IREDELL COUNTY HEALTH DEPARTMENT

IMPROVEMENT PERMIT / AUTHORIZATION TO CONSTRUCT / OPERATION PERMIT / EXISTING SYSTEM INSPECTION

PERMIT# 126498 PIN# 4626327307 / Dave Cote

SUBDIVISION Water Tree Landing BLOCK / SECTION _____ LOT 28 LOT AREA .92Ac SITE CLASS. PS DESIGN FLOW 480gpd L.T.A.R. .25-.3

1"=50' INITIAL SITE SKETCH

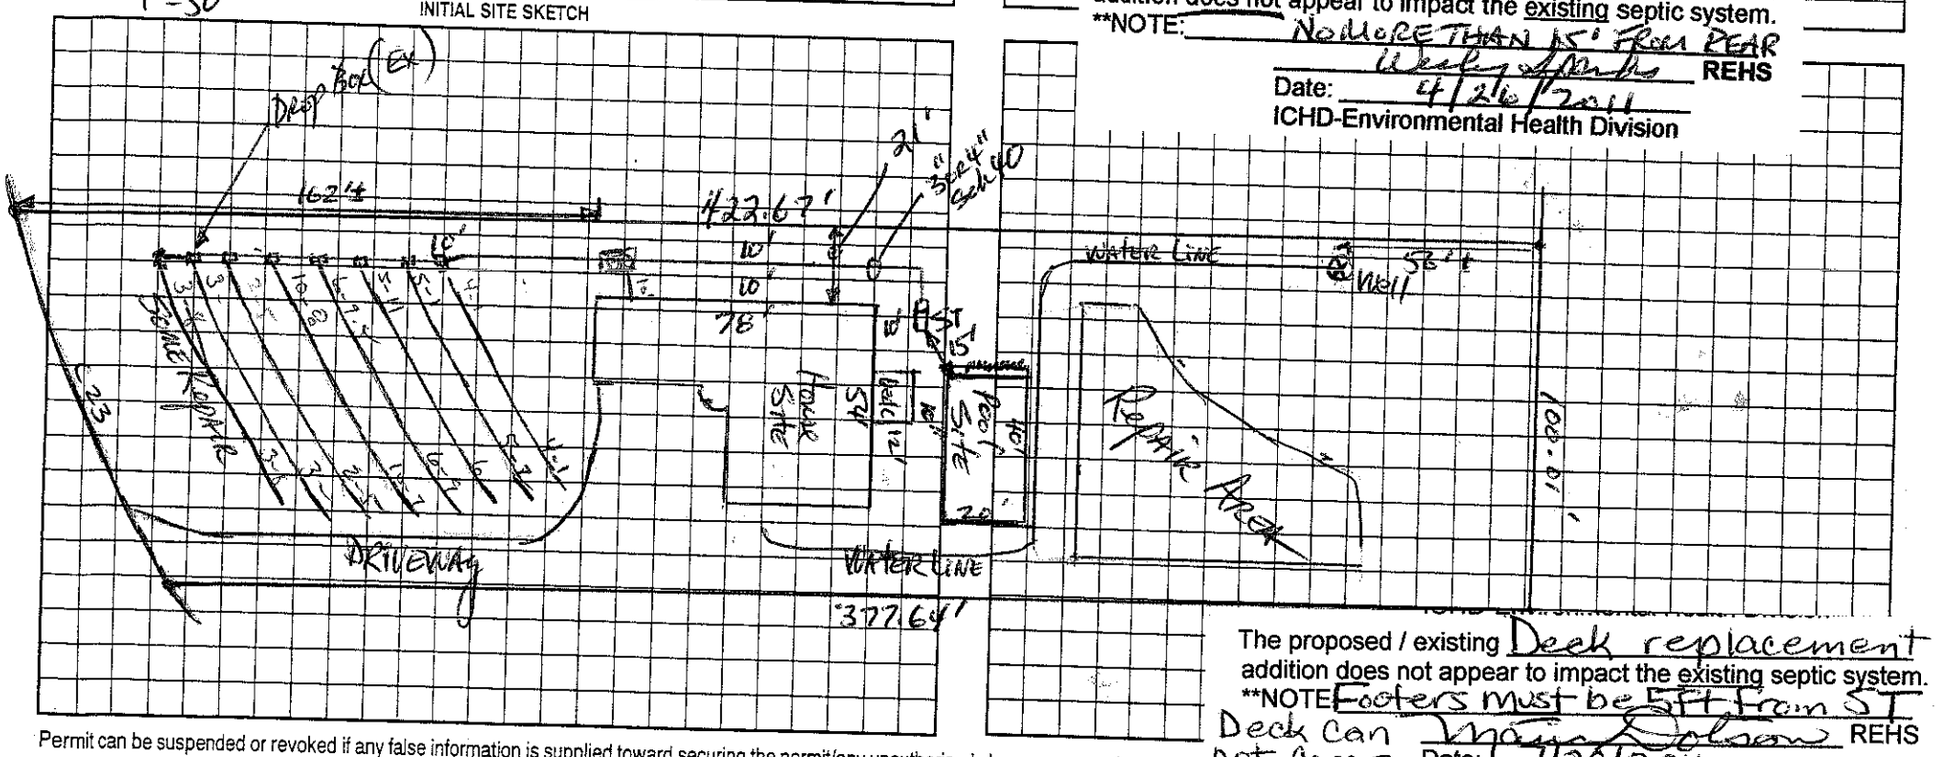
The location of the proposed 3' x 20' Pool addition does not appear to impact the existing septic system.

**NOTE: No More Than 15' From Rear Wall of Home

The proposed / existing Deck replacement addition does not appear to impact the existing septic system.

**NOTE Footers must be 5Ft from ST Deck Can not Cover ST
